Item Name: Mounting Lug

Work Order ID 134229***134229***

DRAWING NO. D2731	TITLE MOUNTING LUG	REV. C	DART AEROSPACE USA, INC ENGINEERING ORDER		D.E.O. NO. D2731-C-1	SHEET NO. SHEET 1 OF 1	SCALE NTS
DRAWN GP	CHECKED SC	MFG. APPR. MA	APPROVED MD		DE APPR. TH		
DATE 11.05.02	DATE 11.05.09	DATE 11.05.09	DATE 11.05.09		DATE 11.05.09

D2731-1RG MOUNTING LUG (SHOWN)
D2731-3RG/-5RG/-7RG MOUNTING LUGS (SIMILAR)

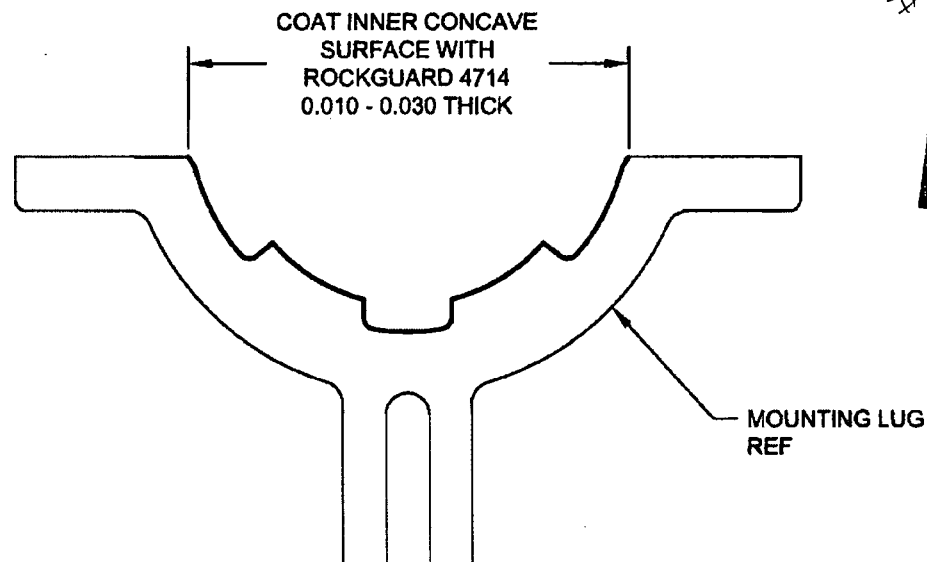
PURPOSE

ADD D2731-xRG OPTION

CHANGE

D2731-xRG MOUNTING LUGS ARE INDENTICAL TO D2731-x MOUNTING LUGS, HOWEVER AFTER FINISH, COAT INNER CONCAVE SURFACE WITH "PLUS ONE ROCKGUARD 4714" AS SHOWN BELOW.
